**City of West Linn Pre-Application Conference  
Tamarisk Subdivision (34-35 lots) (PA-14-16)  
Location: 21E 34A tax lots 600, 690 and 700 (1200 Tamarisk Drive)  
March 20, 2014**

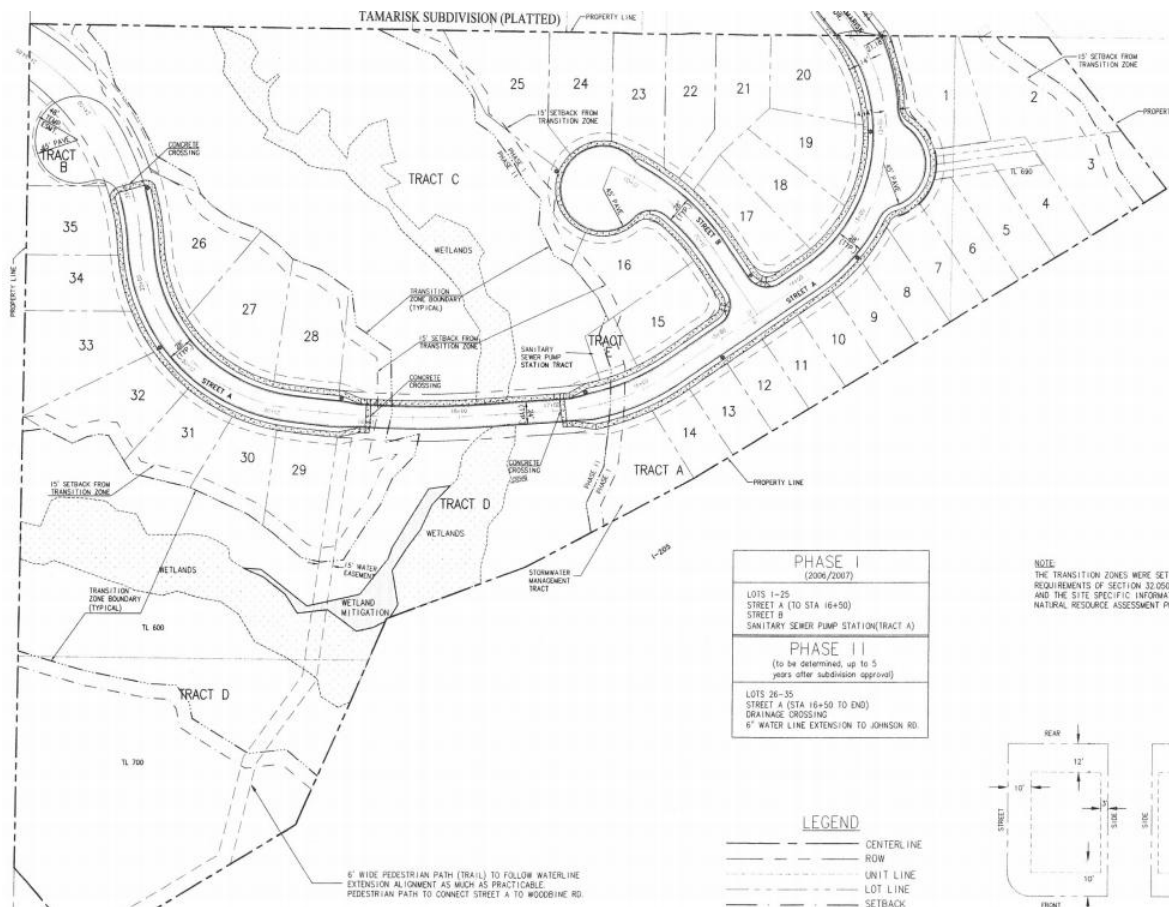
The applicant is considering three possible site plans. One would be to use the 2006 plan shown below (north is on the left side). The advantage of this plan is threefold: it was approved by City Council so there should be a greater measure of certainty associated with its use; second, the creek crossing alignment uses a portion of the Fritchie Creek WRA that has already been disturbed by an earthen road and culvert. And third, fewer significant trees would be removed by this plan compared to the other options proposed by the applicant. Tree loss could be further reduced by redesigning the cul de sac serving lots 21-25.

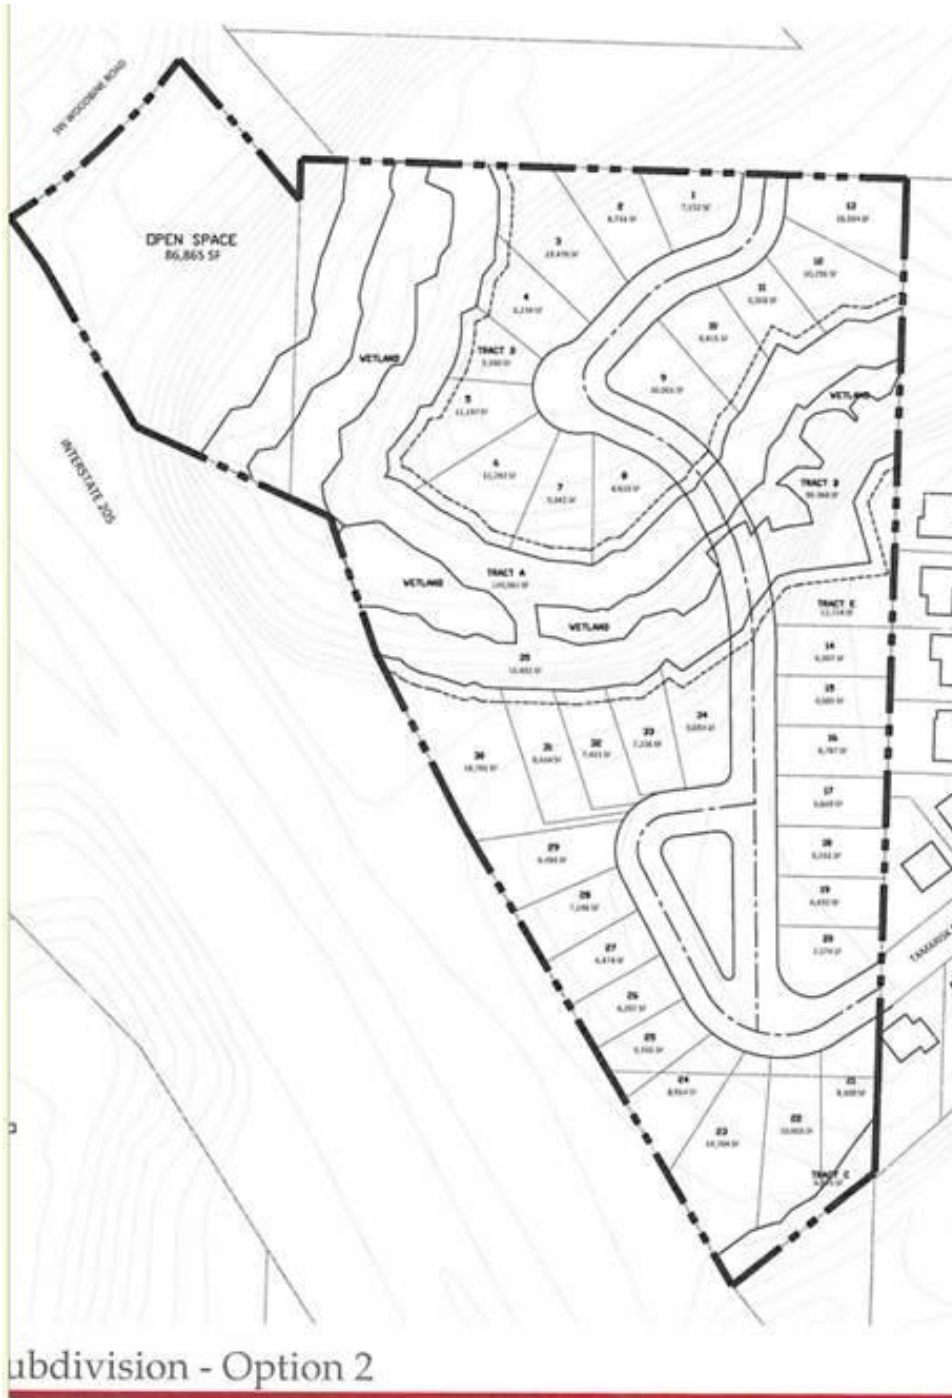
Using the originally approved alignment and stub out of Tamarisk Drive, as shown on this plan, is not regarded by CDC Section 85.200(A) (11) as a cul de sac, so long as there is the reasonable expectation that the road may be extended in the future. (That expectation could be fulfilled by the extension of Tamarisk Drive north through the abutting Burke property, (shown below) across an already culverted developed/disturbed section of Stevens Creek and the up to Woodbine Drive via Burke's property.)

Therefore, no variance is required for the stubbed out Tamarisk Drive. This position was clearly supported by City Council's Finding No. 1 in the Tamarisk appeal decision (MISC-06-46).

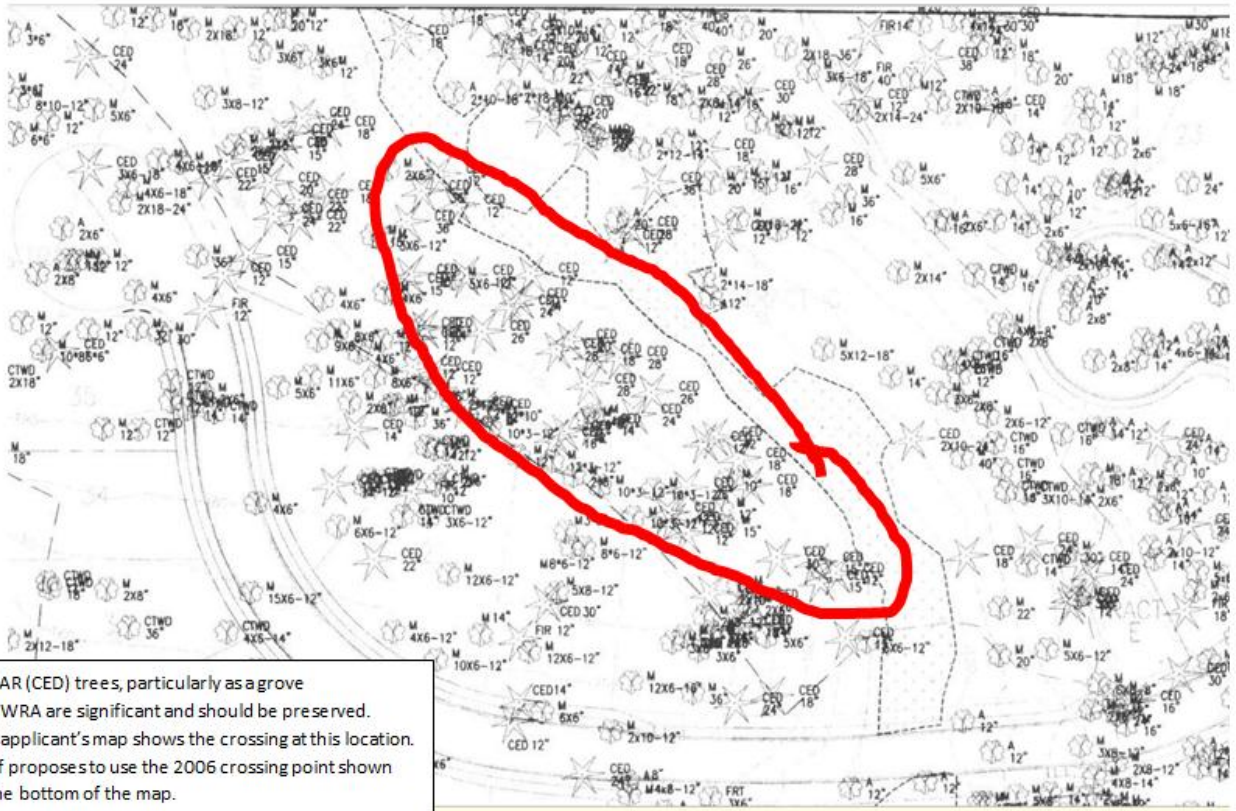
CEDAR (CED) trees, particularly as a grove in a WRA are significant and should be preserved. The applicant's map shows the crossing at this location. Staff proposes to use the 2006 crossing point shown at the bottom of the map.
